NORTHWEST ATLANTA LIBRARY – 100% CD's ADDENDUM #002

June 2, 2014

This Addendum #2 dated June 2, 2014 issued by Brasfield & Gorrie is hereby made part of the Detailed Instructions to Bidders for the Northwest Atlanta Library. The changes and/or clarifications included in this Addendum shall be considered as part of the Bidding Documents and shall supersede, amend, add to, or subtract from those conditions included in the original Bid Documents, including the Project Bid Package, Drawings, Specifications, etc. This addendum must be acknowledged in the space provided on the Proposal Form (included in Section III of the Bid Proposal Form).

Project:	Northwest Atlanta Library
Project No.:	1315.00
Scale:	VARIES
Sheet Ref.:	A-314, A-502
Date:	05/30/14
Revised:	
Drawing No.:	SDA-003

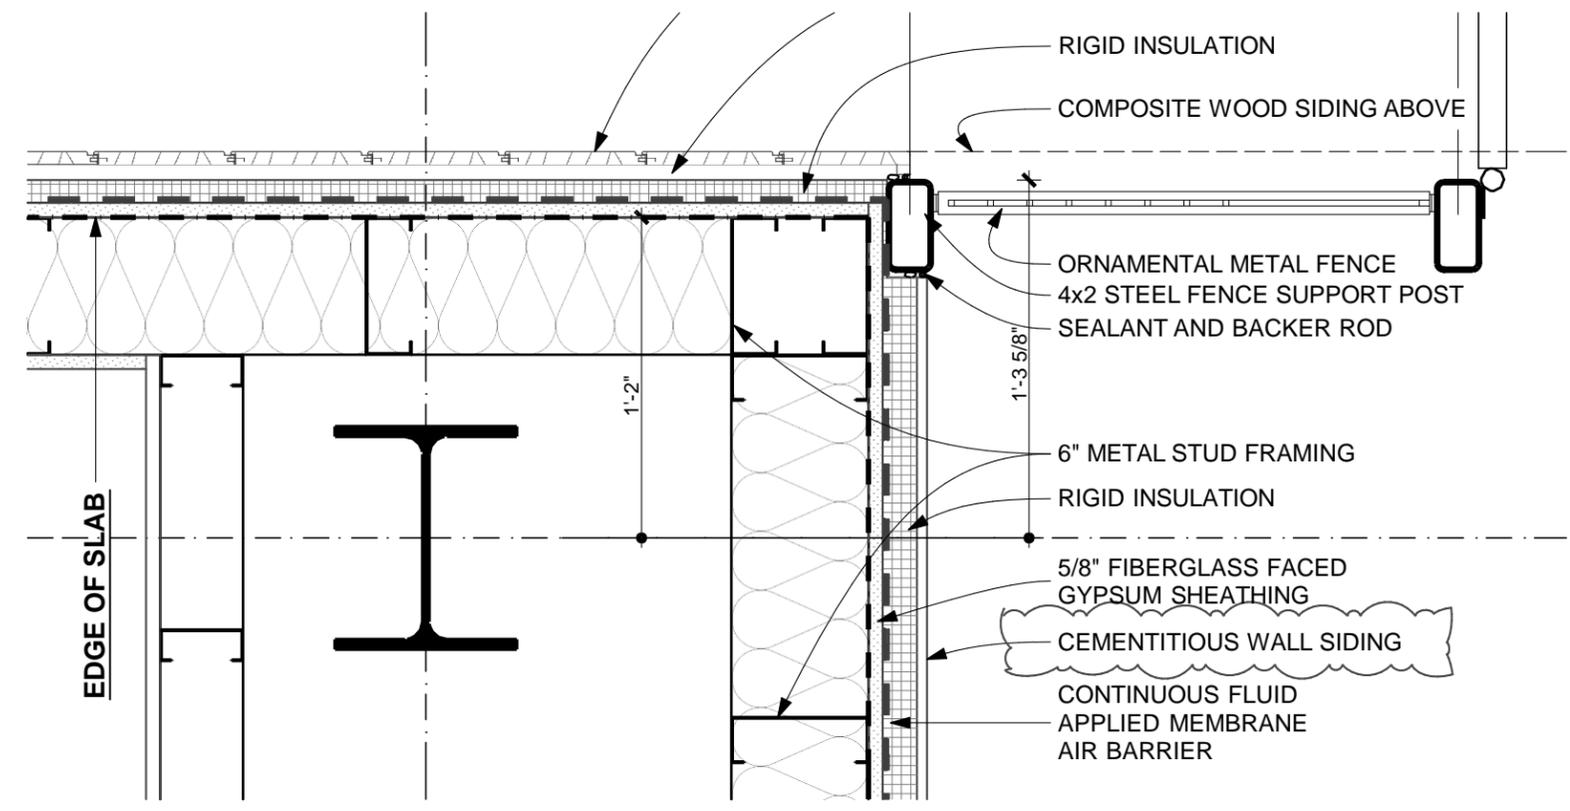
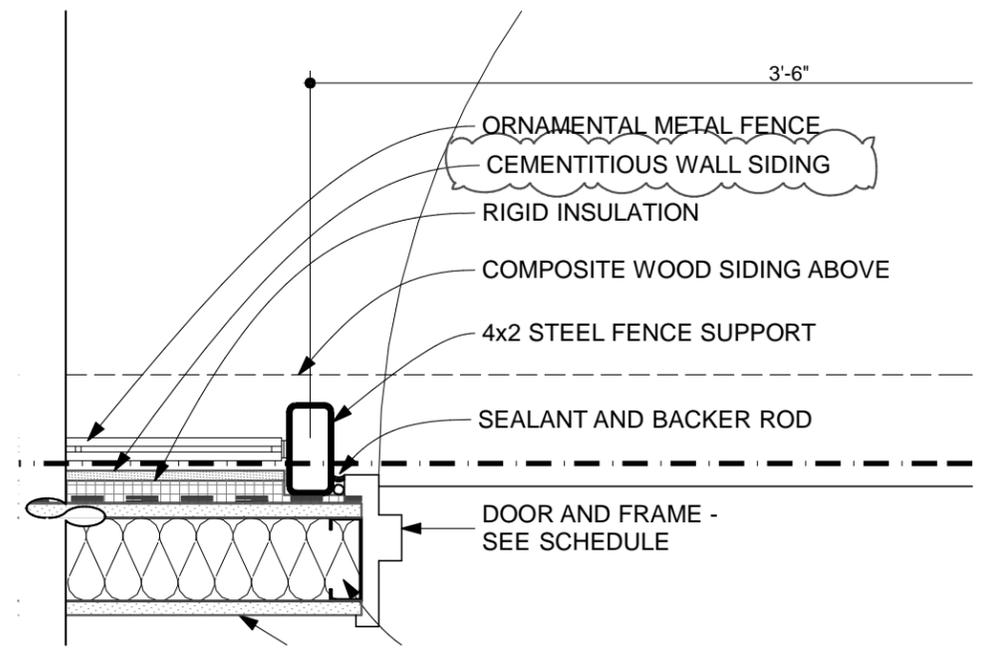
1. Please confirm if the exterior wall at the mechanical space is to be EIFS (6/A-314, 14/A-502) or cementitious wall panels (2/A-201) behind the ornamental wire fence.

Answer #1: Exterior wall in these conditions are to be cementitious wall siding. Refer to attached SDA-003 dated 5/31/14.

Drawing No.
SDA-004

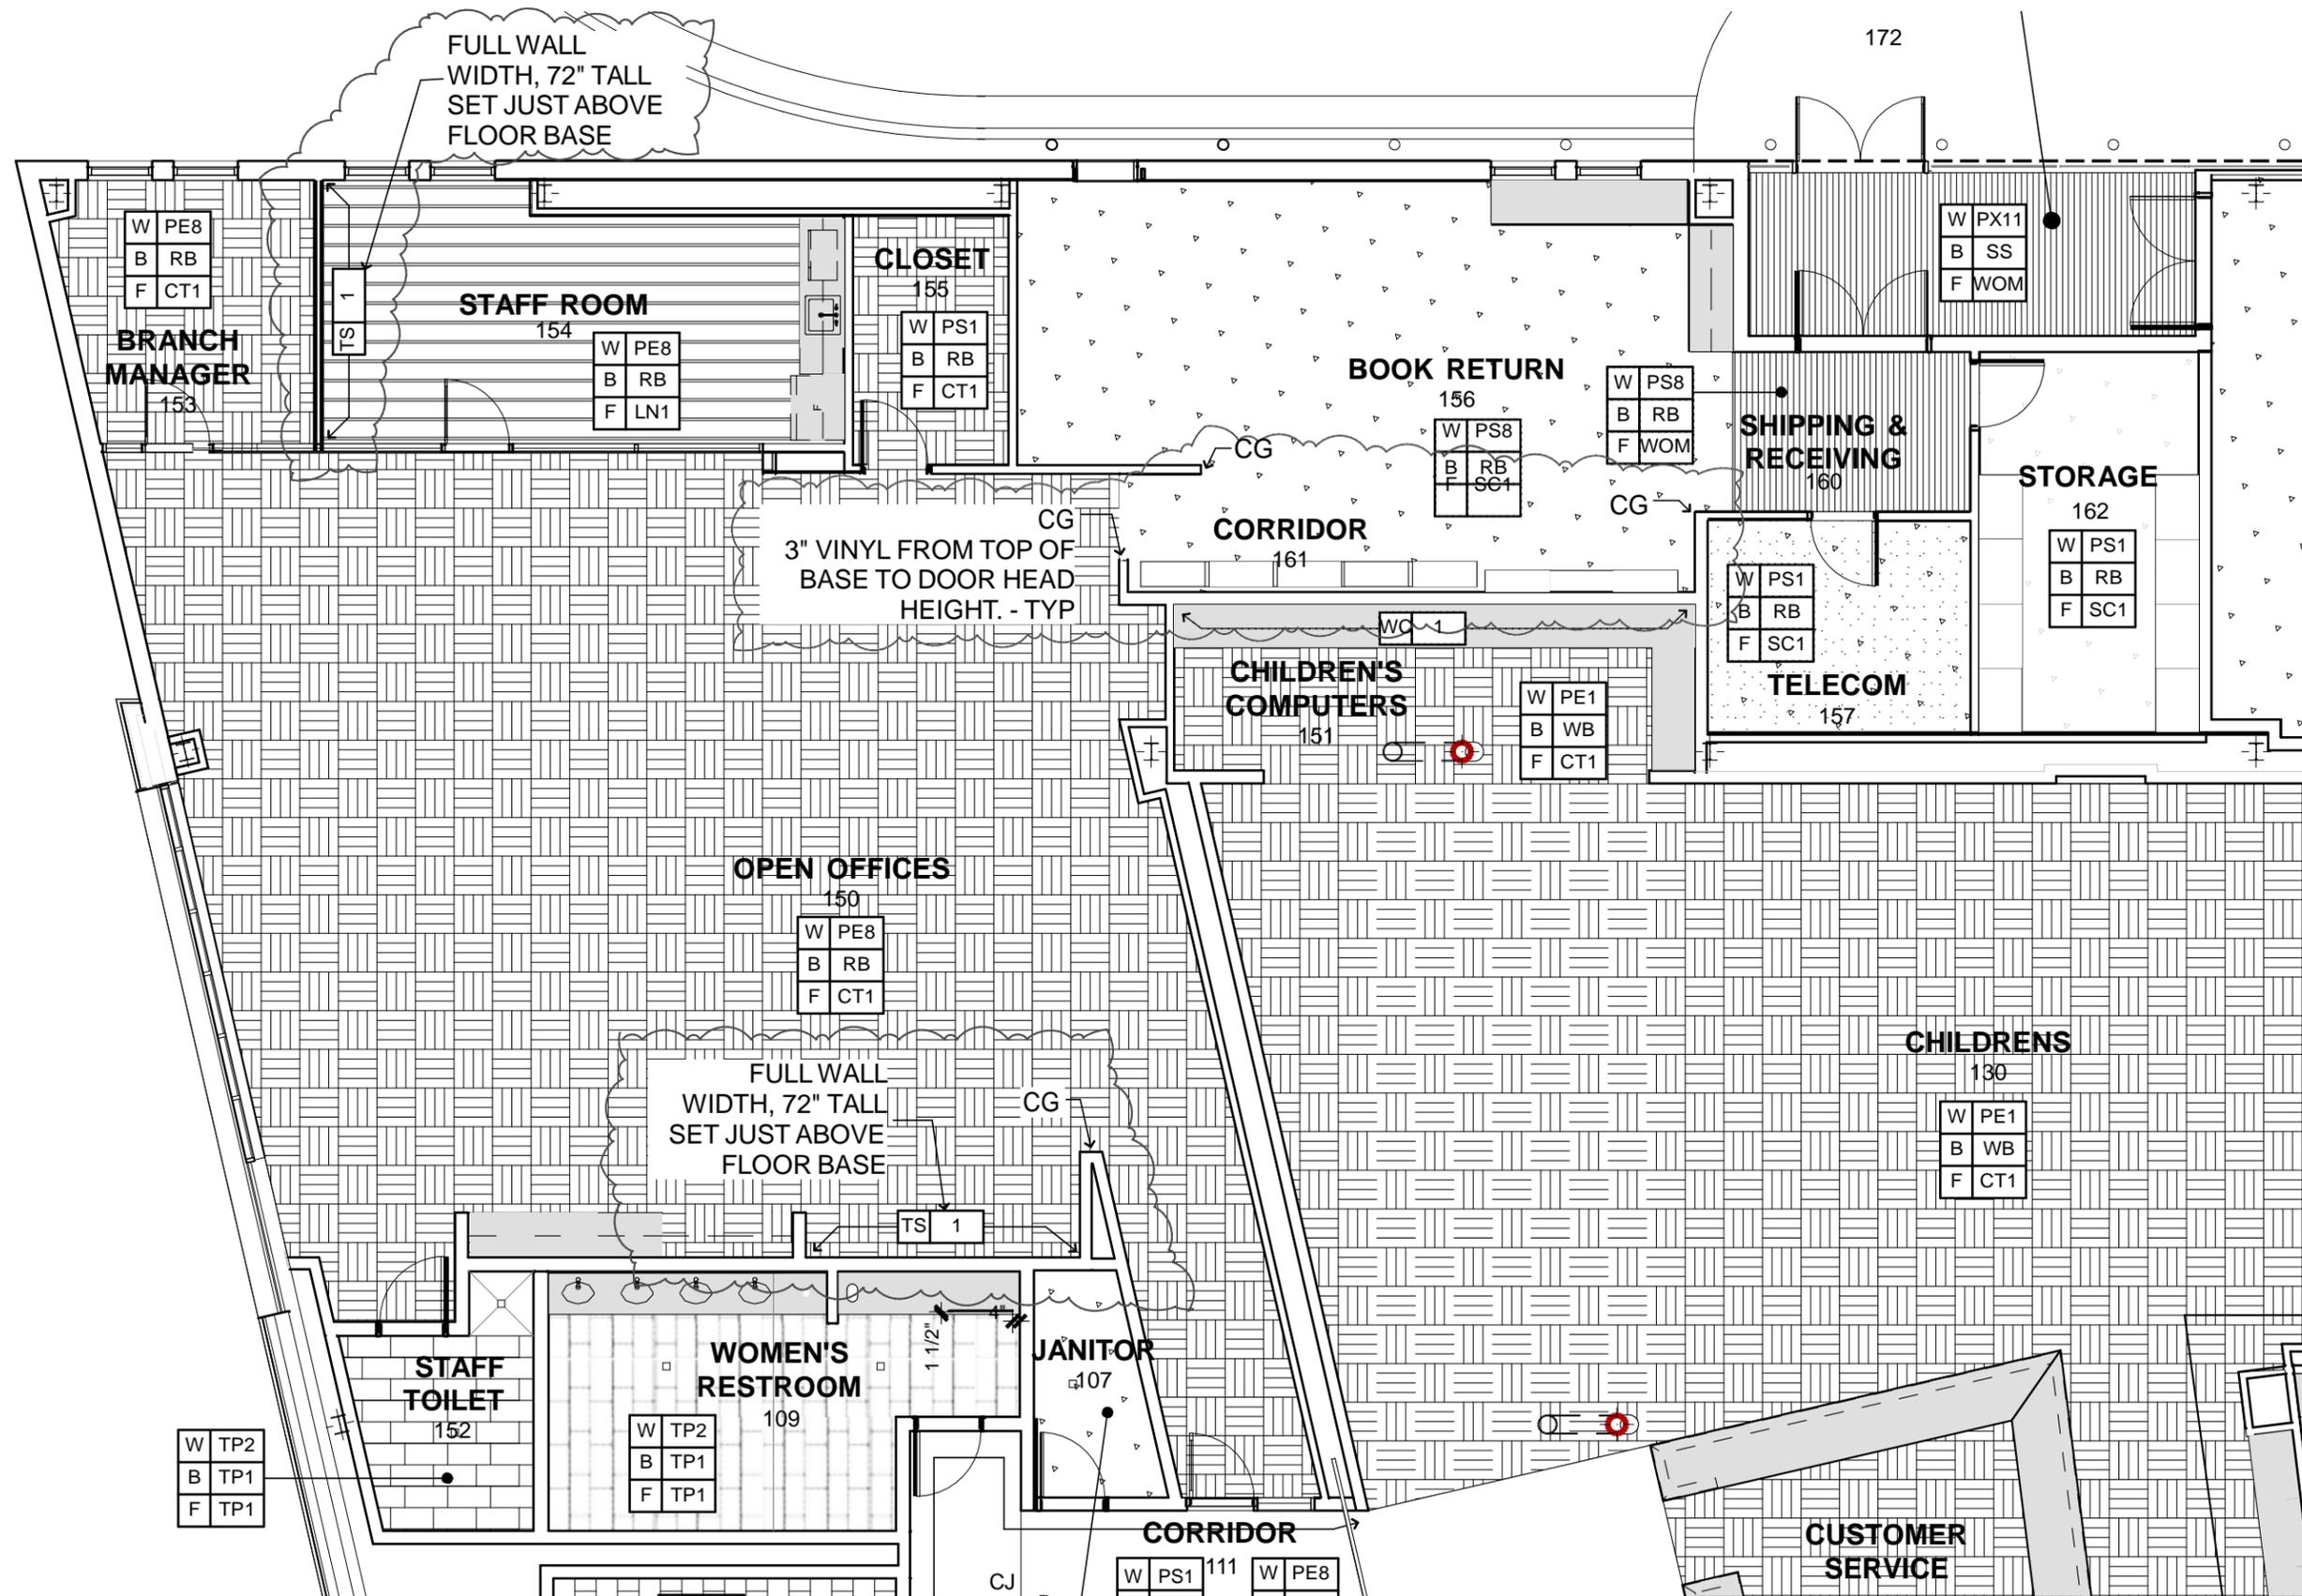
3. Please provide corner guard locations.

10. Please provide clarification on where the tackable surface (TS1) is to be located.

Answer #3: Refer to attached SDA-004 dated 5/31/14 for locations.

Answer #10: Refer to attached SDA-004 dated 5/31/14 for locations.

Drawing No.
SDA-005

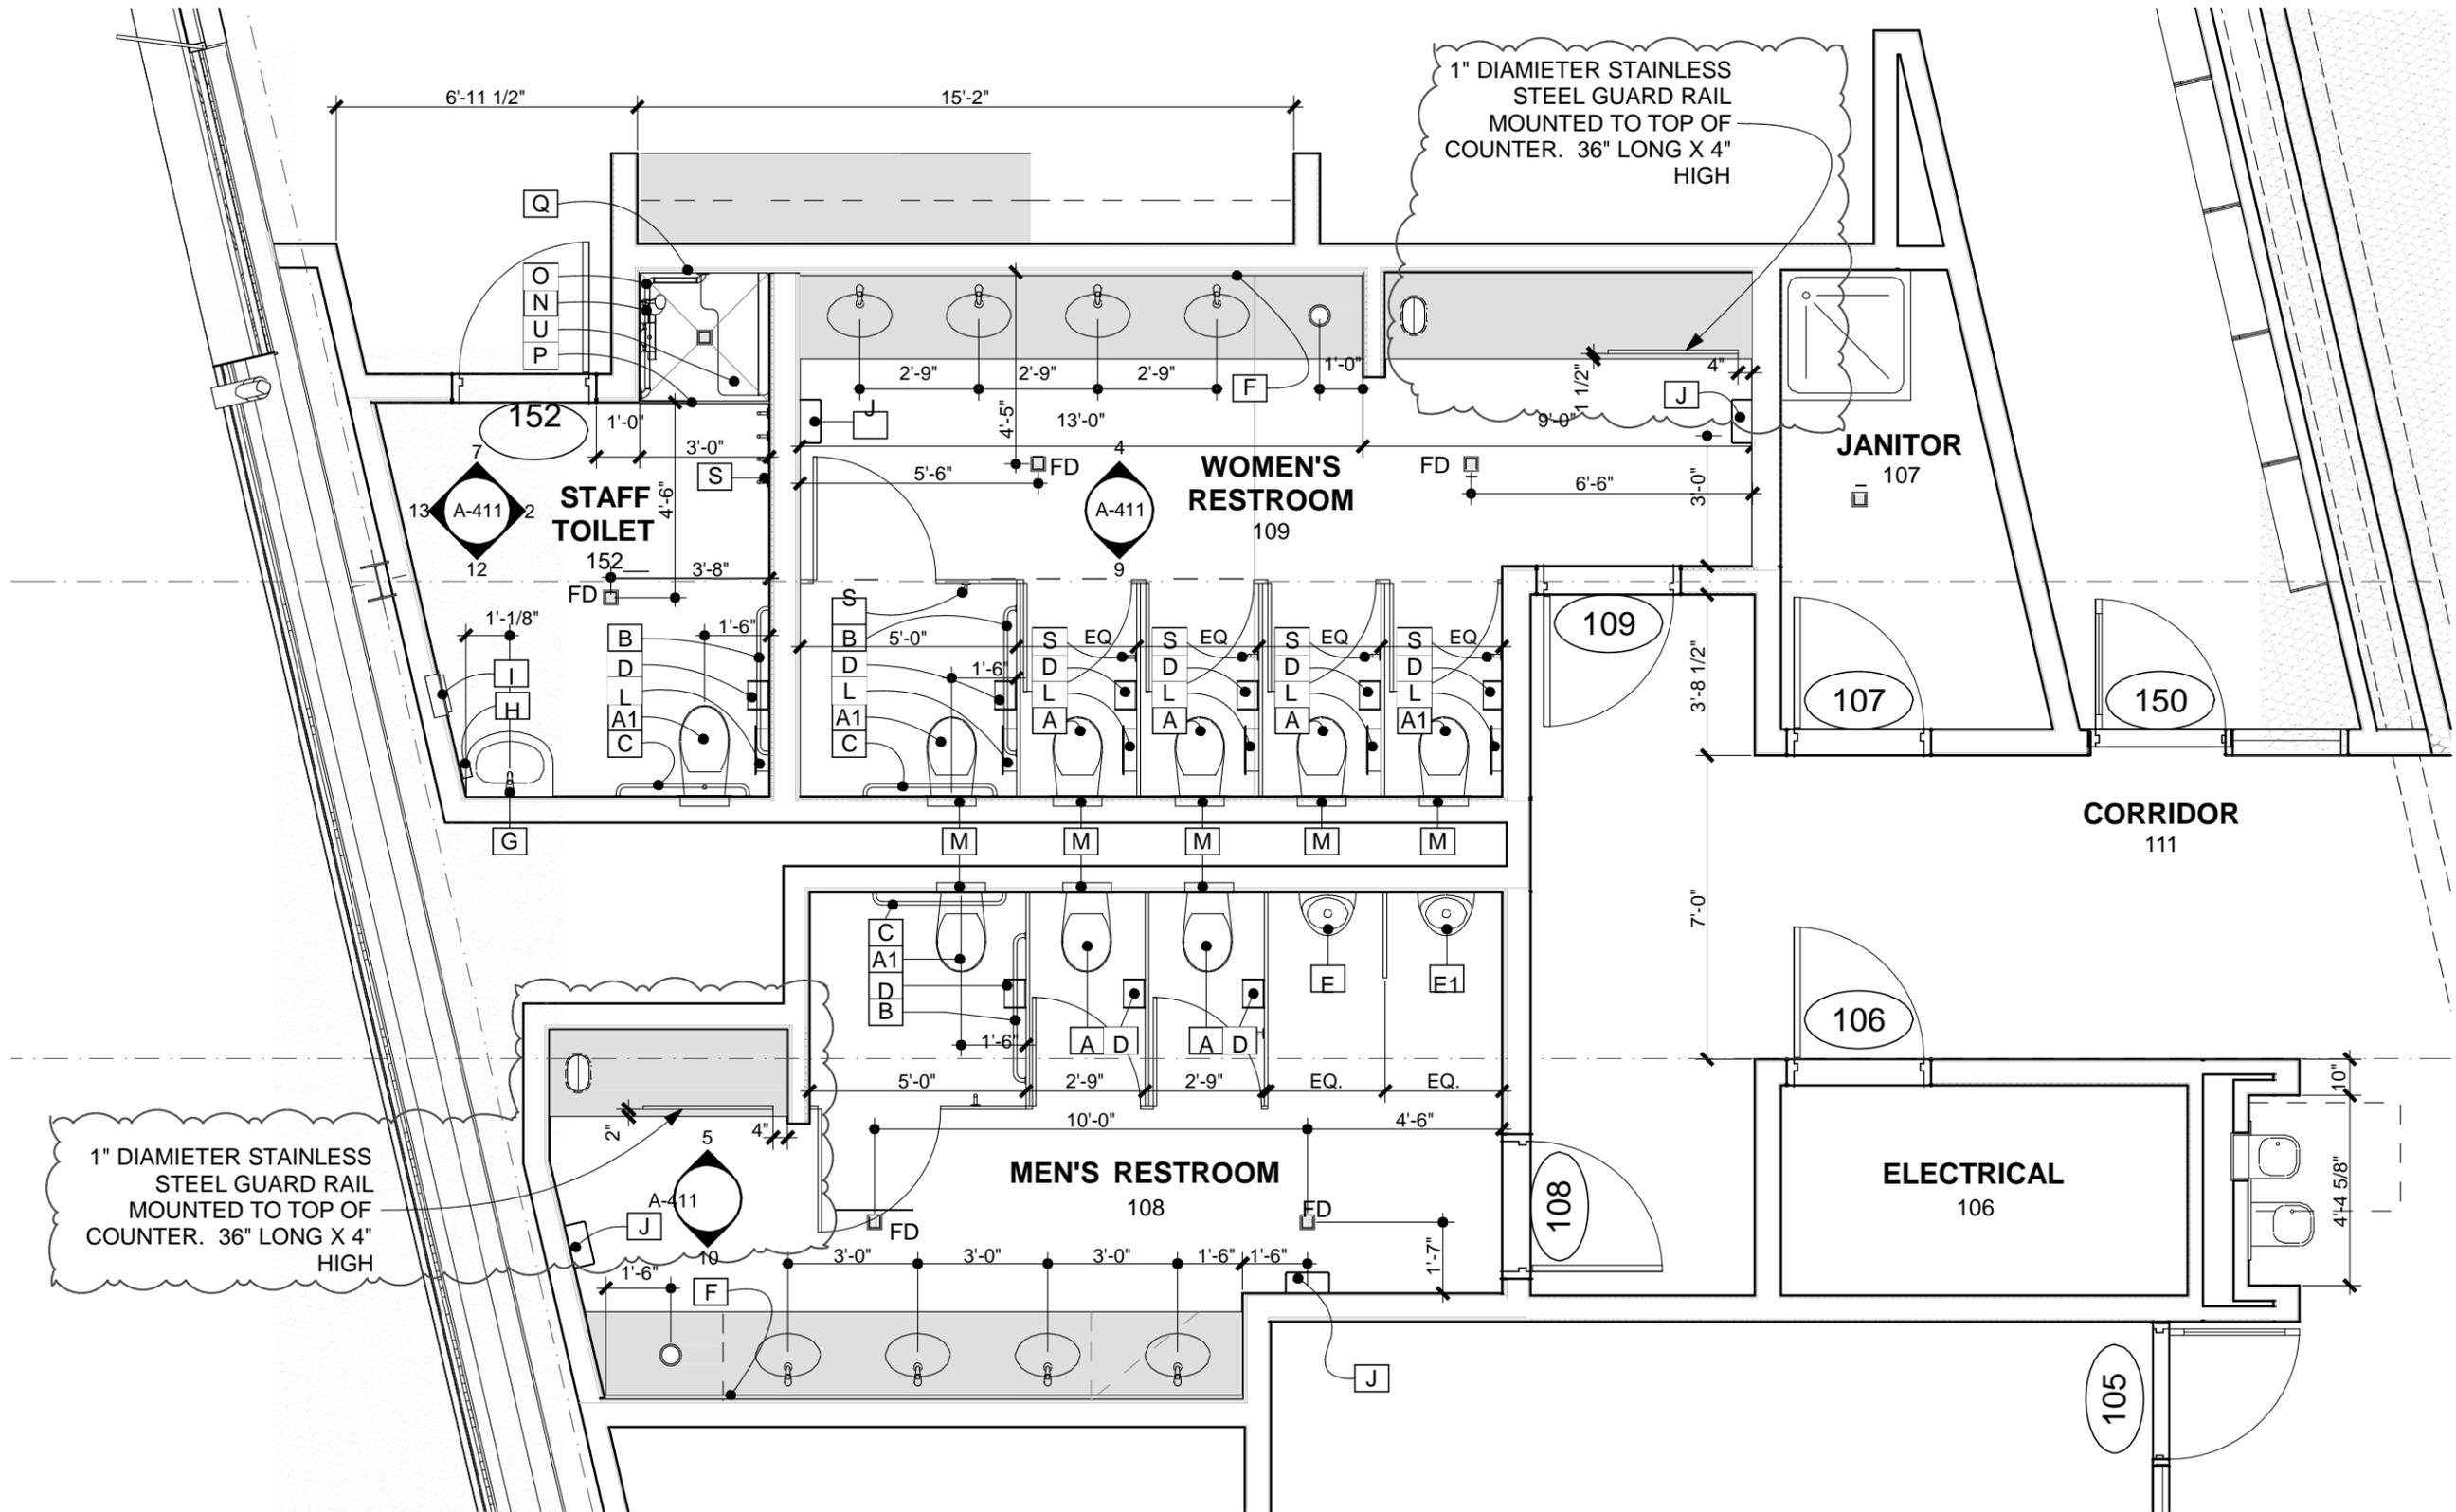
5. Please confirm there are no diaper changing stations. There is a specification, but none are shown on the drawings.

Answer #5: There are no independent diaper changing stations to be installed. Refer to attached SDA-005 for stainless steel guardrail at provided counter that has been included for changing areas.
